# **Integrated Transport Block – A6 to Bramhall Park – Highway Measures**

## **Consultation Summary Report (Dated: July 2024)**

Figure 1: Provide bollards outside the shop at Bramhall Green roundabout.

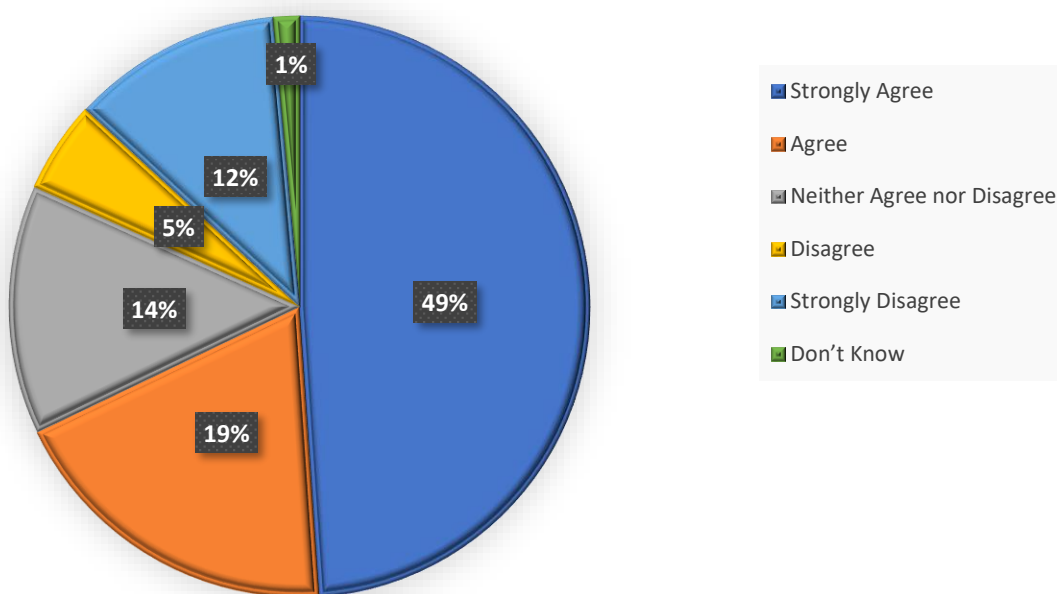
5.6. Of those who disagreed with the provision of bollards, none of the respondents advised that they were responding on behalf of a business or organisation.

roundabout itself which is blocking the shared footway / cycleway in between the car park access and egress and so it is proposed to provide one additional bollard to address this behaviour and improve safety for users of the shared footway / cycleway.

Figure 4: Provide double yellow on the southern side of Bridge Lane between Headlands Road and Valley Road

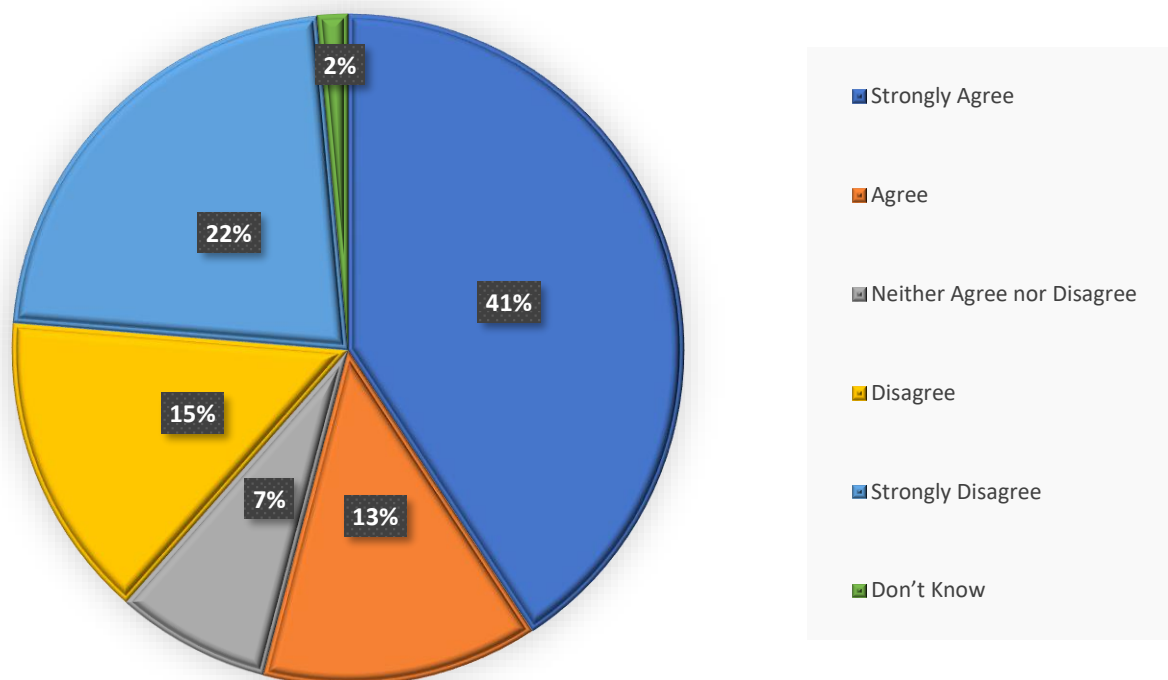
5.20. Interrogation of the comments received to the public consultation identified that two comments were submitted in relation to this question. Both respondents were concerned that the provision of double yellow lines along some sections of Bridge Lane and not others would lead to a concentration of parked cars along the sections which do not include restrictions. One of these respondents asked for the provision of double yellow lines along the section on the southern side of Bridge Lane between headlands Road and Wallbank.

5.21. Consideration was initially given to the provision of double yellow lines along the full extent of Bridge Lane on the southern side to provide support to the cycle lane. Observations of parking identified less issues with obstructions to the cycle lane between Bramhall Moor Lane and Headland Road and so it was agreed with ward members that this section could remain unrestricted and that this could be reviewed should issues arise.

5.22. No changes have been made to the proposals in response to the feedback received to this question.

*Figure 5: Provide double yellow lines at the junction of Bridge Lane with Headlands Road and Walmer Drive*

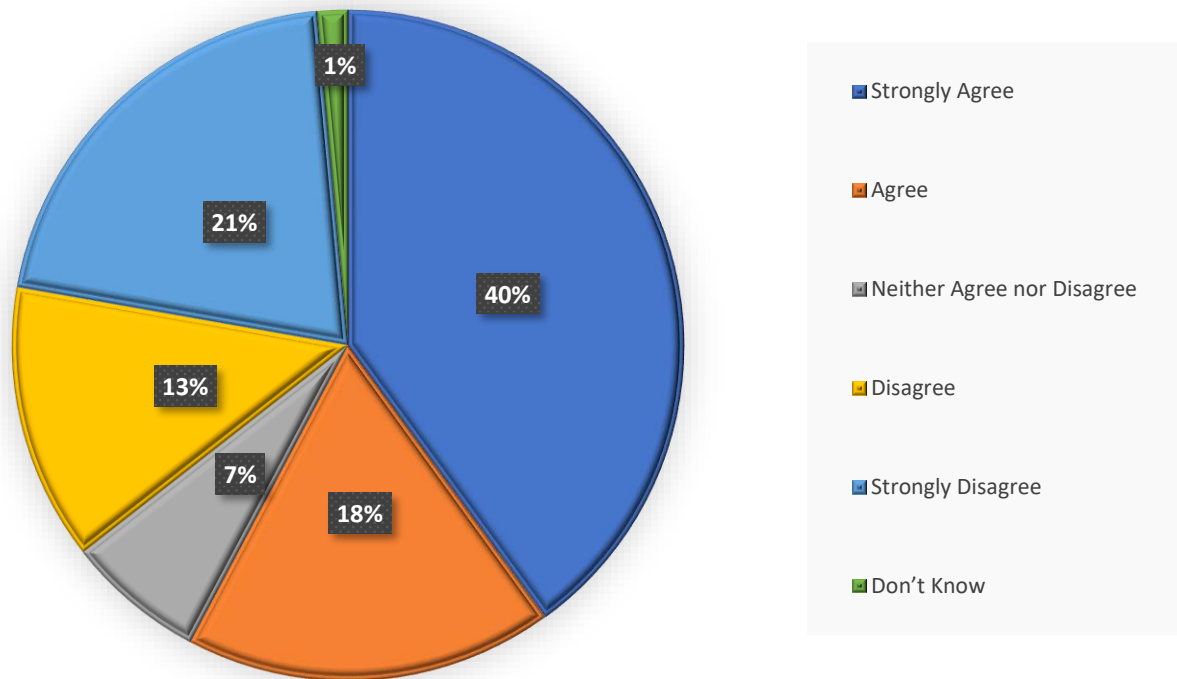
5.25. Interrogation of the comments received to the public consultation identified that one comment was submitted in relation to this question. The respondent did not support the provision of double yellow lines at these junctions, advising that the cycle lane is not well used, parking across the cycle lane is rare and that they were not aware of any issues associated with the occasional parking that does occur in this area.

5.28. No changes have been made to the proposals in response to the feedback received to this question.

*Figure 6: Provide double yellow lines on all approaches to the Jacksons Lane/ Bramhall Moor Lane/ Laneside Drive/Bridge Lane roundabout*

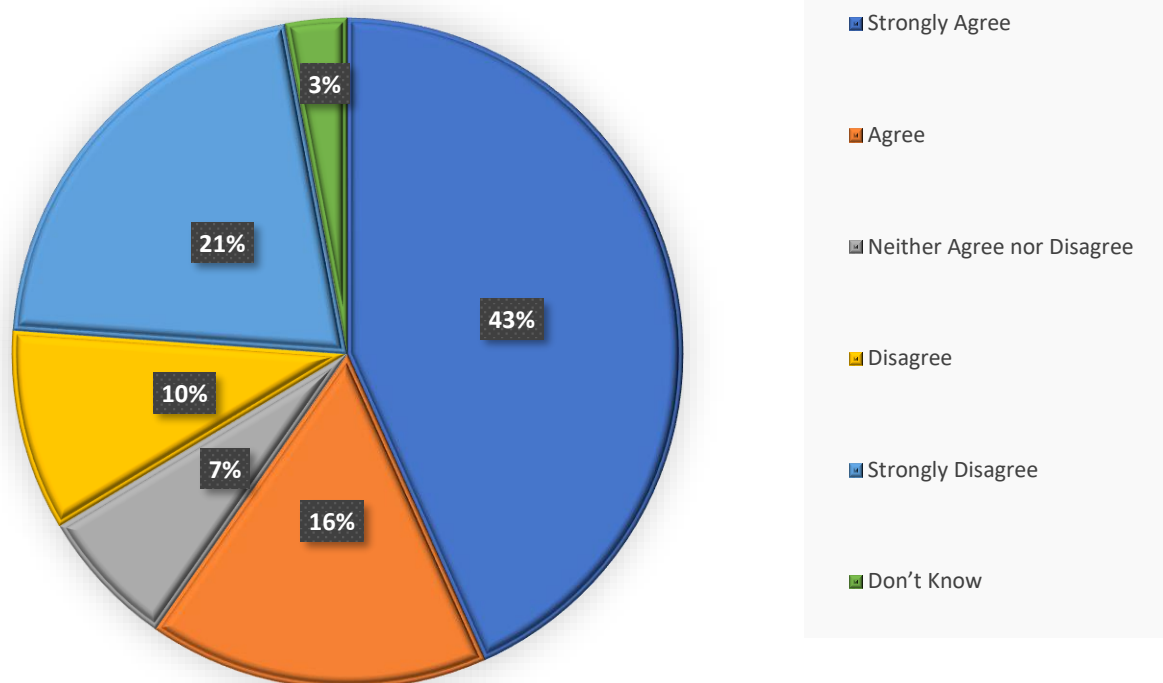
5.31. Interrogation of the comments received to the public consultation identified that there were three comments which directly related to this question. Two respondents were opposed to the proposals raising concerns regarding double yellow lines being put outside their properties as this would reduce the available on-street car parking provision and cause difficulties with receiving deliveries and obstruction caused by the cycle lane. Another respondent advised that they had raised concern about issues with parking on the grass verge along Bridge Lane to ward members. Whilst they were generally supportive of the provision of double yellow lines, they were concerned that the proposals could lead to an increase in parking on the grass verges.

- 5.33. There is also an online form that can be completed to request a dispensation to park in a restricted area (e.g. to get permission to park on yellow lines). Whilst this service does not provide for general visitors, it could be used to allow tradespeople to park at a specific location when required and can be accessed at the following webpage:  
<https://www.stockport.gov.uk/start/request-a-parking-dispensation>

- 5.34. No changes have been made to the proposals in response to the feedback received to this question.

*Figure 8: Provide double yellow lines on the northern side of Jacksons Lane between the recently consented Laurus Grace School access and the Jacksons Lane/ Dorchester Road roundabout, and on all approaches.*

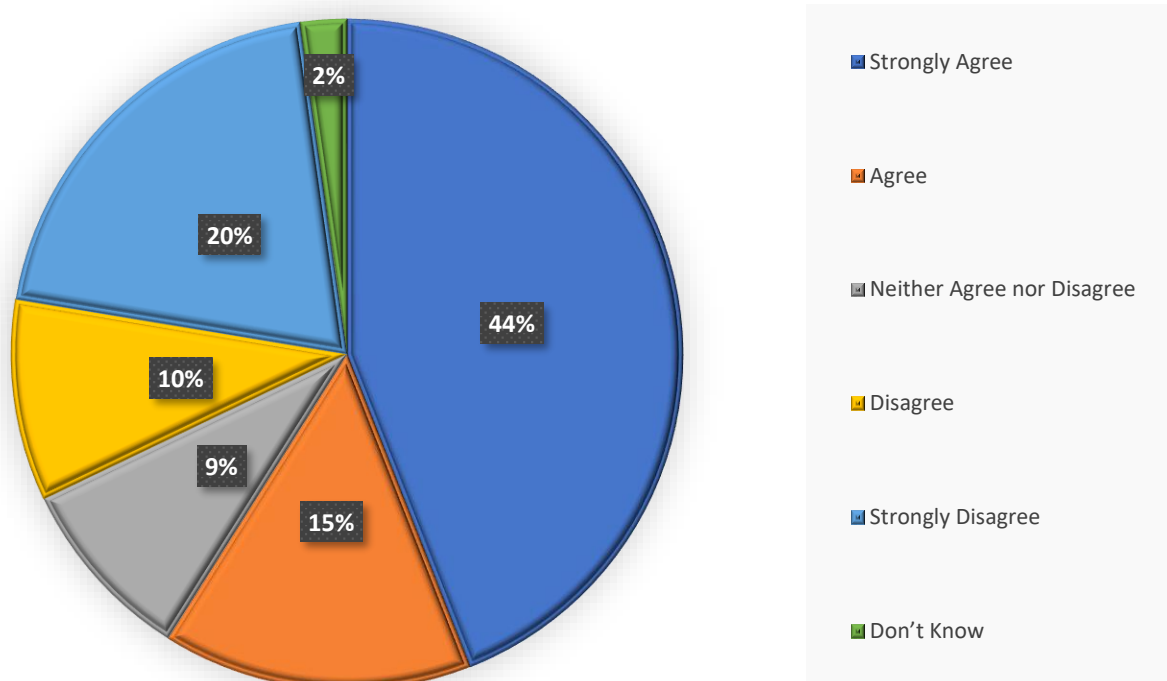
- 5.41. In relation to this question, 4 comments were received. 75% were in support of the proposals for double yellow lines along this section. Only one comment raised concern as they believe that even though the proposals will allow the cycle lane to be unobstructed it will not make cyclists use the cycle lane and congest the road.

- 5.42. The cycle lane was introduced to provide a facility which is segregated from the main vehicular traffic along the corridor in order to make journeys easier and more attractive for all users and make active travel a more attractive choice. A key aim of the scheme was to encourage people to cycle who would not have previously as cycling on the carriageway was too off-putting for them. Confident and experienced cyclists may choose to continue riding on the carriageway as they do elsewhere on the highway network.
- 5.43. No changes have been made to the proposals in response to the feedback received to this question.

Figure 11: Provide double yellow lines on the southern side of Jacksons Lane between the eastern end of the lay-by and Dorchester Road, with bus stop markings provided for the bus stop outside Hazel Grove High School

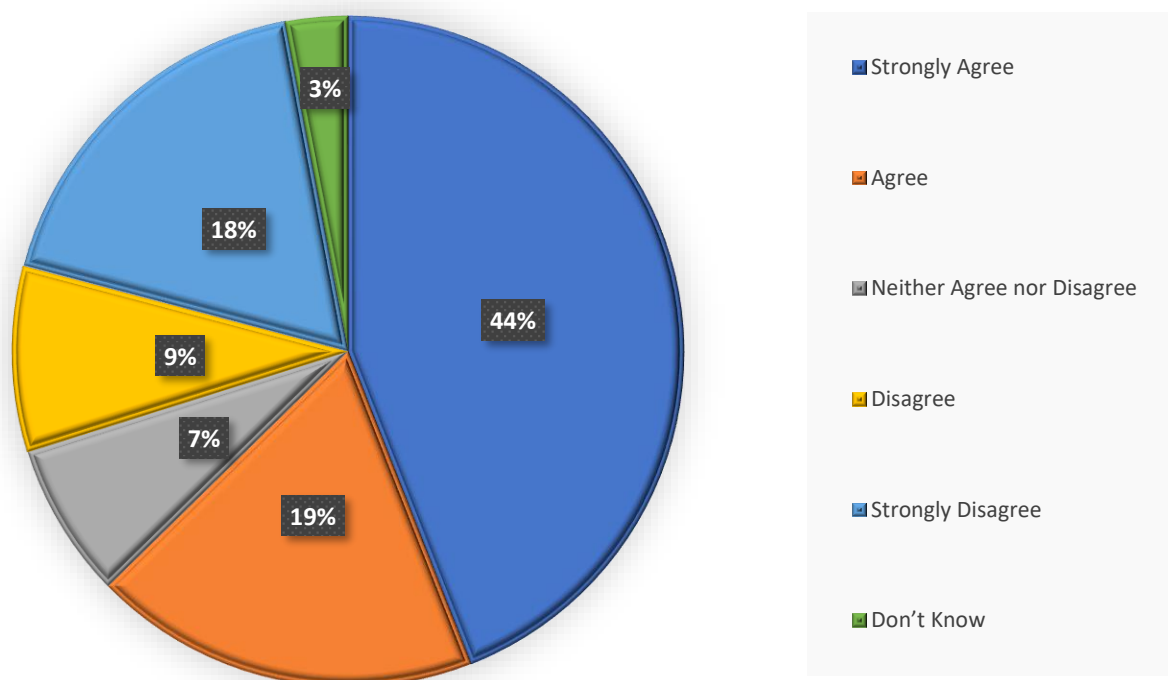
5.54. One respondent submitted a response which specifically related to this question, with two respondents also providing e-mail feedback and one respondent following up with a phone call; as summarised within Section 5.89. The respondents raised concern about the interaction between motorists exiting the driveways along this section and cyclists travelling close to the hedge within the shared space which has led to recent near misses. They have requested a review of the signage within this area directing cyclists to the northern side of the shared space. One of these respondents expressed support for the proposed parking restrictions to prevent parking on the footway along the section of shared space.

- 5.55. The proposed measures were well supported by respondents to the public consultation and so are proposed to be retained within the proposals.
- 5.56. With regards to the existing cycleway this section has been implemented as shared pedestrian / cycleway as there was insufficient width available to provide a segregated facility. A review of the on-site provision has highlighted that the corduroy hazard warning paving should have been provided to the west of the lay-by in order to highlight the start of the shared space. It is proposed that this be provided as part of the revised scheme. It is also proposed to provide additional signage and line markings on the shared footway / cycleway to raise awareness of the concealed driveways in order to improve safety.

*Figure 13: Provide double yellow lines at the junction of Dean Lane / Bowerfield Avenue and Bowerfield Avenue / Charnwood Crescent*

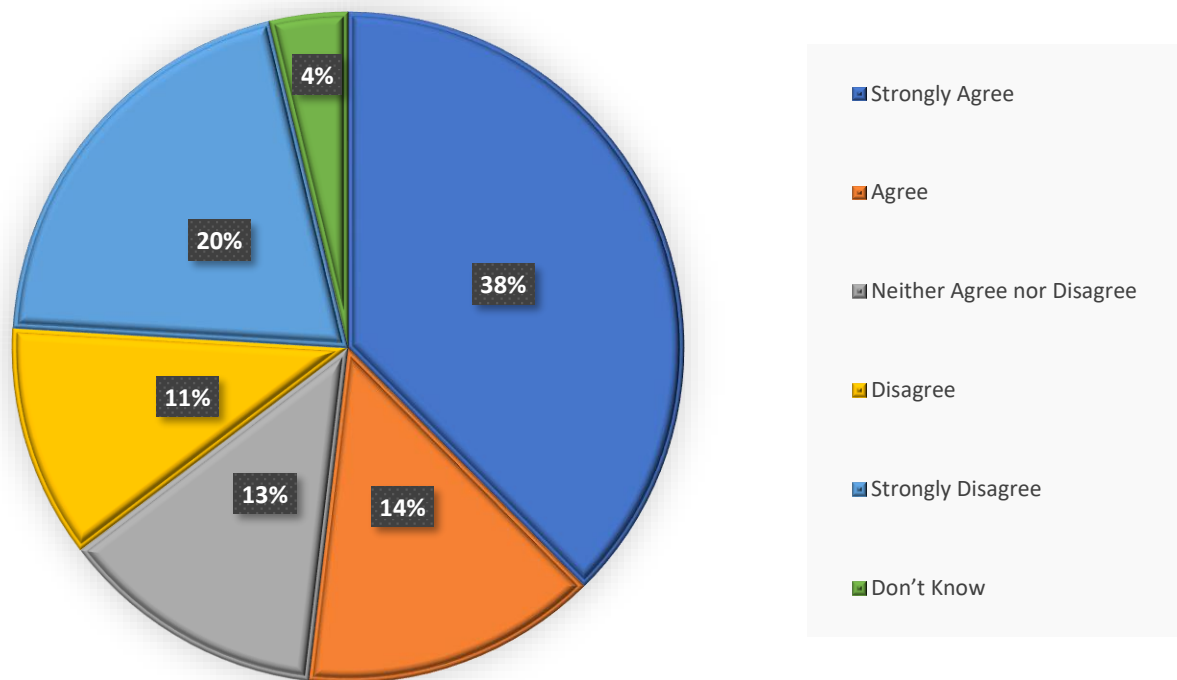
5.65. As described in Section 5.87 an email response was also received to request that the proposed No Waiting At Any Time restrictions be extended on the northern side of Dean Lane, to the east of Bowerfield Avenue.

5.68. The proposed No Waiting At Any Time restrictions are proposed to be extended by 11m in response to the consultation feedback received.

Figure 14: Provide double yellow lines at the junction of Dean Lane / Rutland Road

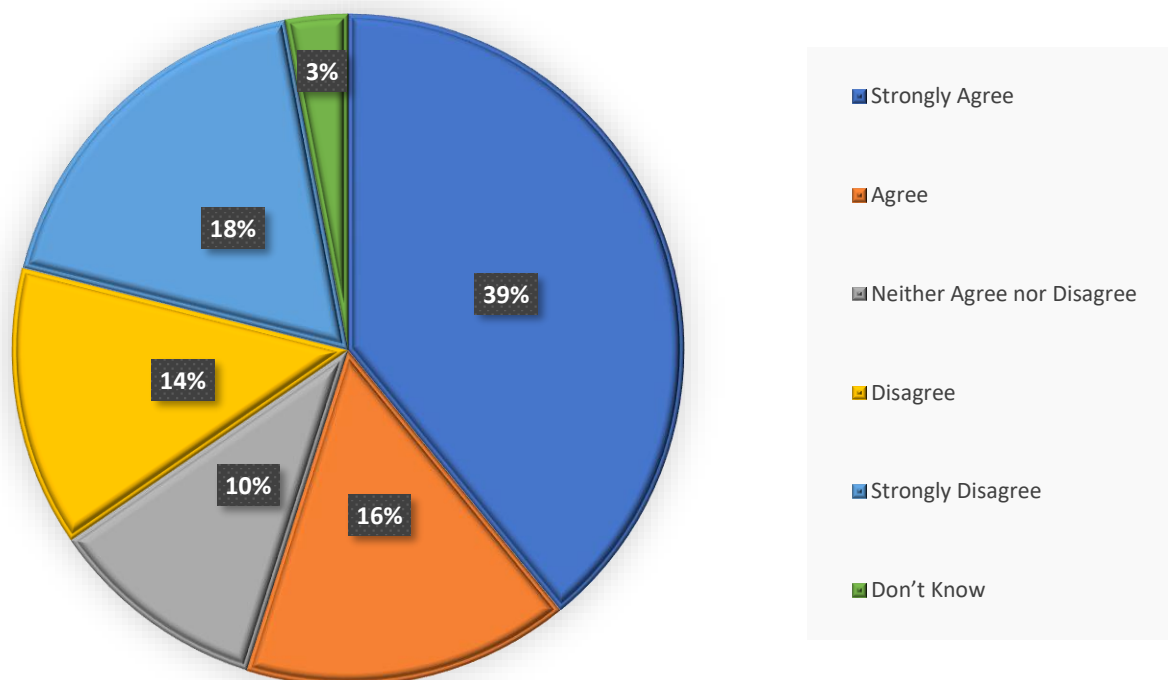
- 5.71. Interrogation of the comments received to the public consultation identified that there was one comment made in relation to this question with the respondent opposed to the proposals as they will prevent residents from parking outside their properties. The respondent comments that Rutland Road is already within a 20mph zone and considers that the nature of the junction already provides good visibility for all users.

- 5.72. The proposed restrictions would protect the intervisibility between pedestrians and motorists whilst also ensuring vehicles can negotiate the junctions safely. It would also reinforce Rule 243 of the Highway Code which prohibits parking within 10m of a junction.
- 5.73. No changes have been made to the proposals in response to the feedback received to this question.

Figure 17: Reduce the length of the clearway on Macclesfield Road and replace with double yellow lines and No Loading At Times Shown restrictions

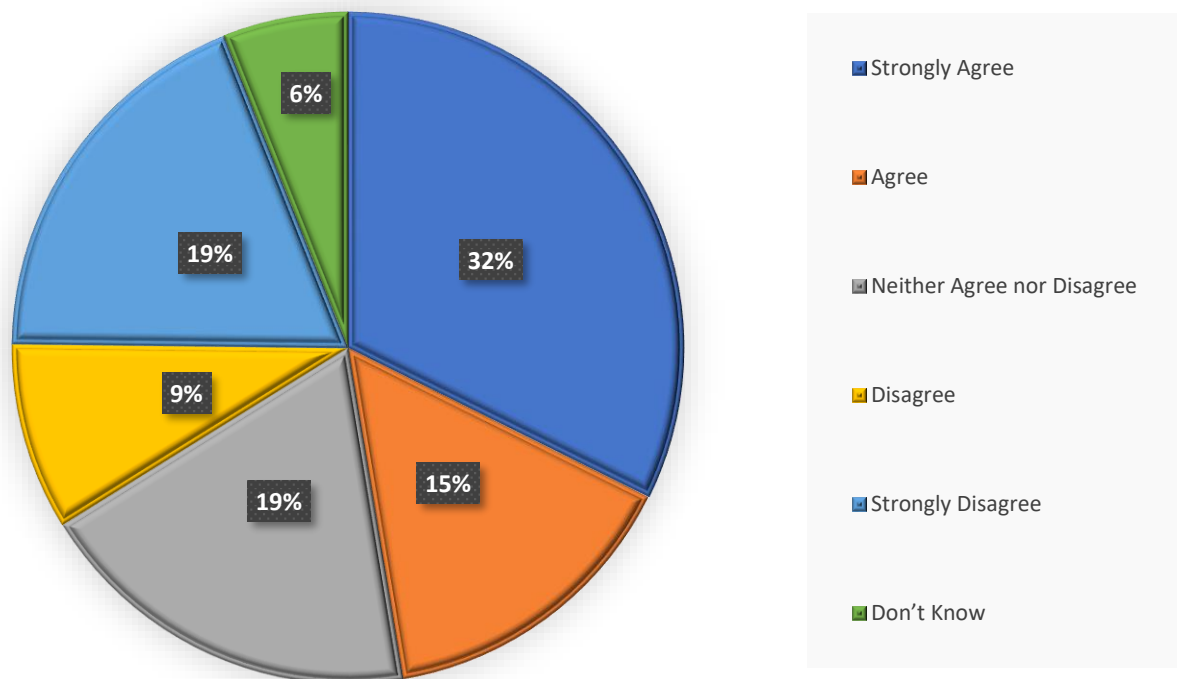
- 5.86. As set out in Section [xx], there were also two e-mails received in relation to this question. Both respondents strongly objected to the proposals. Both respondents advised that they had previously requested on-street car parking provision on the eastern side of Macclesfield Road and understood that whilst this had not been provided they would be able to continue parking at the back of the wide footway due to limited off-street car parking availability.

- 5.88. The proposed restrictions would not prohibit vehicles from pulling off the carriageway and utilising the footway to then reverse onto the driveway if there is insufficient space within the property to turn vehicles around.
- 5.89. No changes have been made to the proposals in response to the feedback received to this question.
